U.S. NUCLEAR REGULATORY COMMISSION

Reports No. 50-266/89033(DRP); 50-301/89033(DRP)

Facility Name: Point Beach Unit 1 and 2

Areas Inspected: Special, unannounced inspection by resident inspectors of issues relating to the inadequate original design of the facility's DC electrical distribution system and the licensee's corrective actions.

Attachment: DC Electrical Distribution System

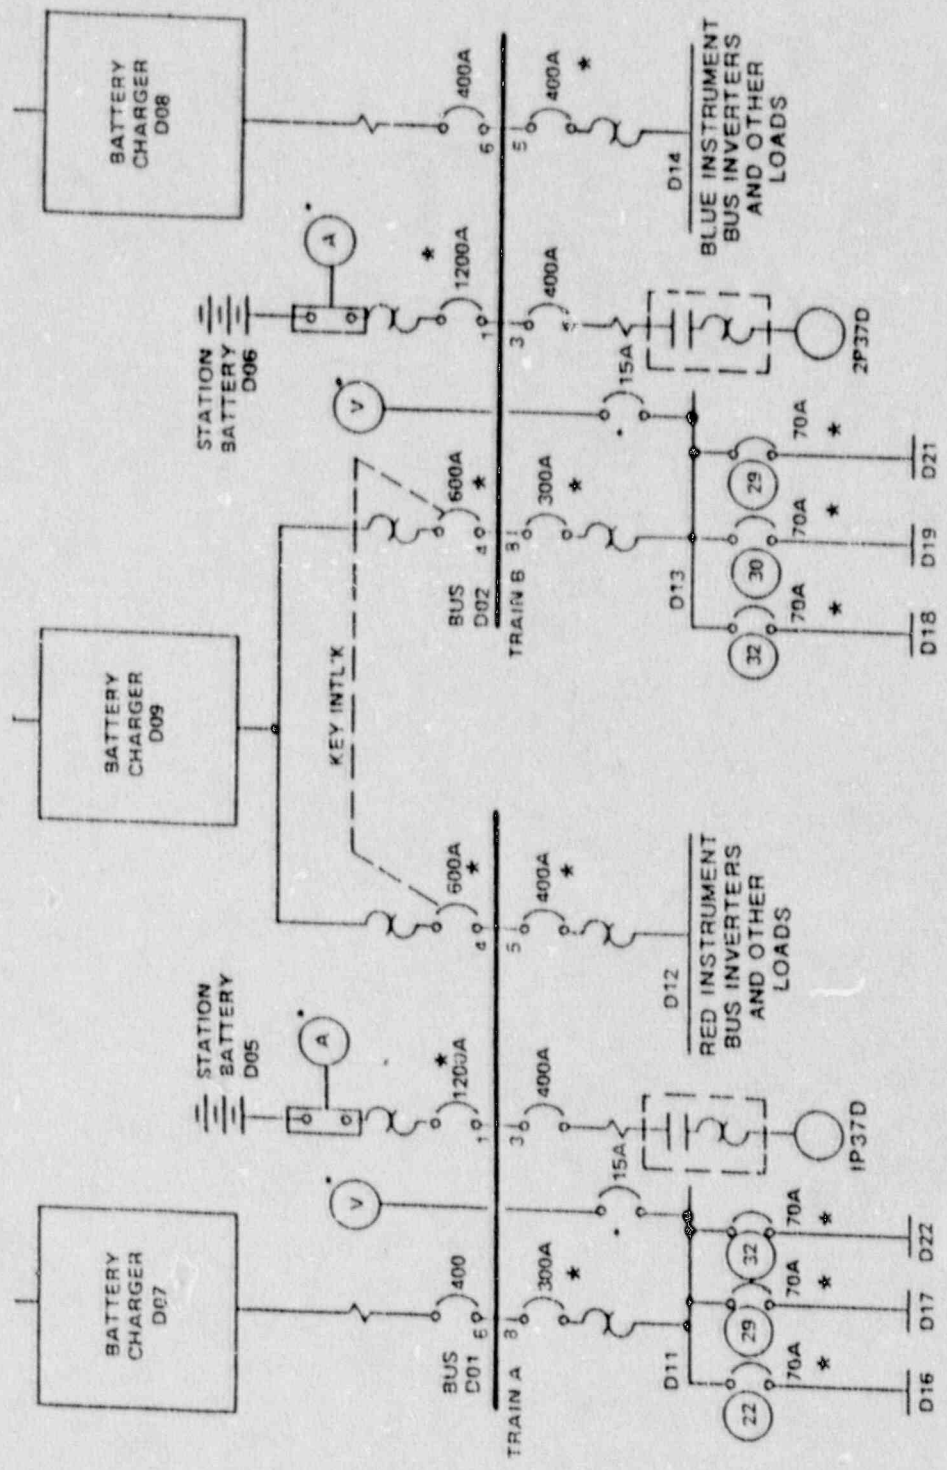
The original facility design utilized thermal-only trip breakers on the lines connecting the main DC busses (D01 and D02) to the DC distribution panels (D11, D12, D13, and D14); to the batteries (D05 and D06); and to the common battery charger (D09). The remaining lines to the independent battery chargers (D07 and D08) and to the turbine emergency lube oil pumps (1P37D and 2P37D) were equipped with breakers having thermal and magnetic tripping capabilities. These conditions are still present at the facility.

Two of the DC distribution panels (D11 and D13) have 32 breakers on each panel. Of the 32 breakers on each panel, 30 were equipped with thermal-only trip capability. The other two breakers on panels D11 and D13 and all the breakers on panels D12 and D14 were equipped with breakers having both thermal and magnetic tripping capabilities.

Further analysis by the licensee's engineering group identified the possibility of generating a fault current on a nonsafety load commonly supplied by distribution panels D11 and D13 in excess of the tripping capability of the thermal-only breakers. A fault on one of these non-safety related circuits could result in currents which would not be interrupted by any of the breakers in the DC system. This could result in the fault current being sustained until one of the components in the DC system catastrophically fails or until both batteries supplying the system are discharged to a point where they can no longer provide sufficient energy for their safety-related functions.

The licensee's onsite DC distribution system was not capable of providing sufficient independence assuming a single failure due to an original plant design deficiency regarding installed DC breakers. This failure to provide sufficient independence and separation for the DC distribution system in accordance with the applicable design documentation is an apparent violation of 10 CFR 50, Appendix A, Criterion 17 (266/89033-01 and 301/89033-01).

Breakers for unit 1 nonsafety-related loads on station battery D05 were replaced with breakers equipped with thermal and magnetic tripping capabilities returning D05 to an operable condition.

Further actions were taken to replace breakers for unit 2 nonsafety-related loads with breakers equipped with thermal and magnetic tripping capabilities. This allowed the reconnection of these loads to the DC busses and permitted the restart of unit 2.
